**CERTIFICATE OF APPROPRIATENESS**

**Property:** 1810 Kane St, Lot 6, Block 443, Baker W R NSBB Subdivision. The property includes a historic 1,400 square foot, one-story wood frame single-family residence situated on a 5,000 square foot (50' x 100') interior lot.

**Proposal:** Alteration – Replace the existing tapered porch columns with new tapered porch columns and remove a porch header.

**PHOTO BEFORE WORK COMPLETED**

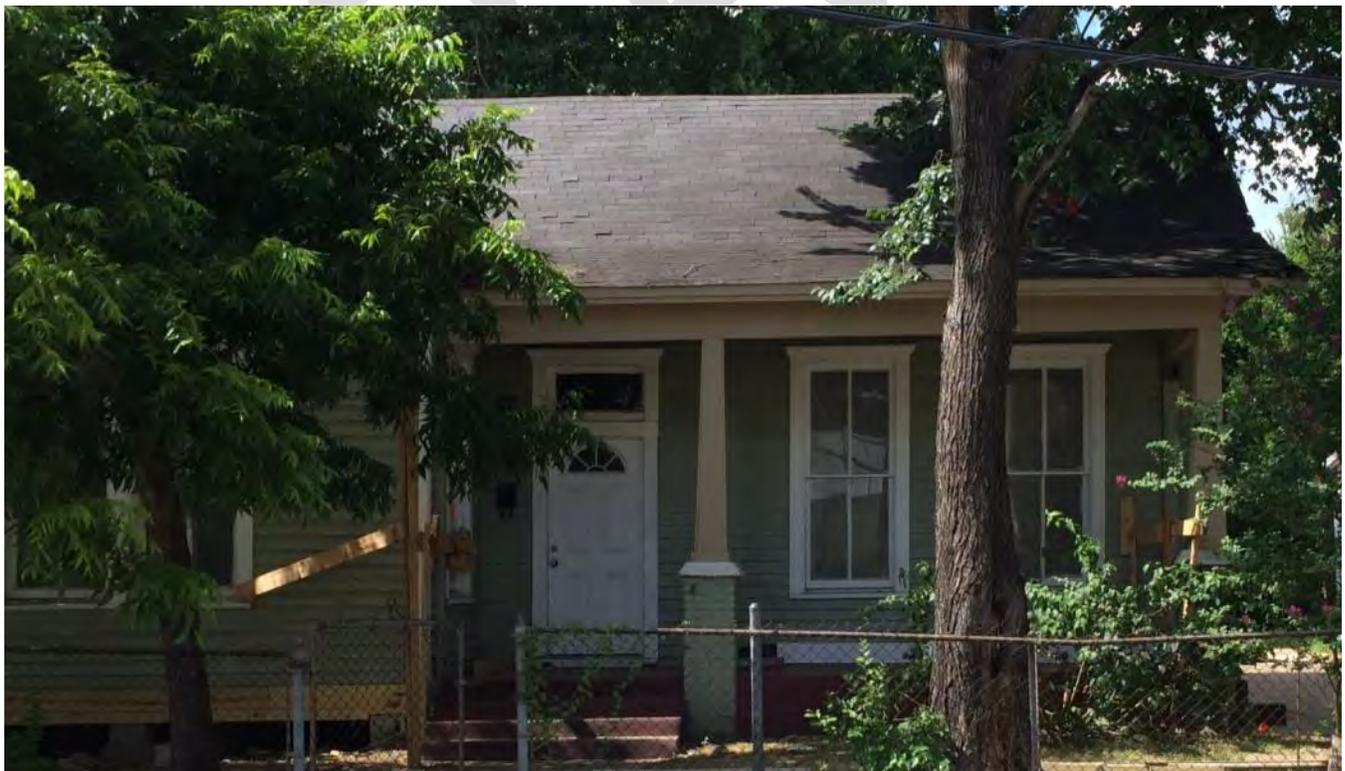
The applicant reframed the porch roof, removed a header and replaced the tapered columns without a COA or permits.

**Front Elevation:** The elevation contained two brick piers with plywood tapered columns. The applicant removed a porch header and the tapered columns and installed thinner and taller fibrous board columns with a wood-grain finish.  
**(South)**

**Recommendation:** **Approval with conditions: Reinstall the missing header above the porch and install turned columns to match the existing engaged columns.**

**SOUTH ELEVATION – FRONT FACING KANE STREET**

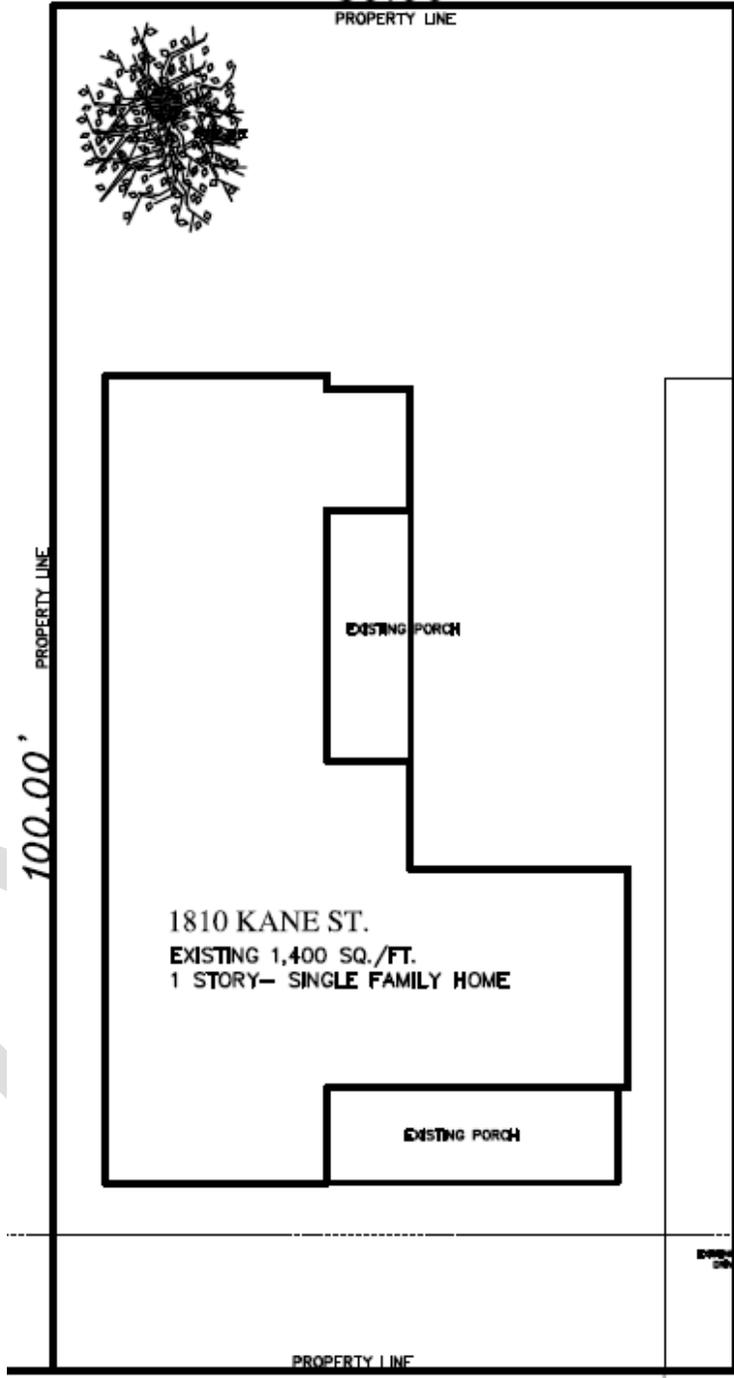
|                                     | <input checked="" type="checkbox"/> | <input type="checkbox"/>            | (1) The proposed activity must retain and preserve the historical character of the property;<br><i>The removal of the tapered columns and header results in the loss of historical character and the new tapered columns do not match what was removed. The installation of turned columns that match the engaged column swill preserve the historical character of the property.</i>  |
| <input type="checkbox"/>            | <input checked="" type="checkbox"/> | <input type="checkbox"/>            | (5) The proposed activity must maintain or replicate distinctive stylistic exterior features or examples of skilled craftsmanship that characterize the building, structure, object or site;<br><i>The new tapered columns do not match the ones removed. The project would meet this criterion if new turned columns that match the engaged ones were installed.</i>  |

\* The replacement columns for 1810 Kane do not comply with the Old Sixth Ward (OSW) design guidelines or the HPO regarding materials for replacements. We would prefer you to return the house to the original turned Victorian columns, consistent with its original date of construction. If you replace the columns as is, we require that you replace with like-materials and duplicate the profile of the existing columns.
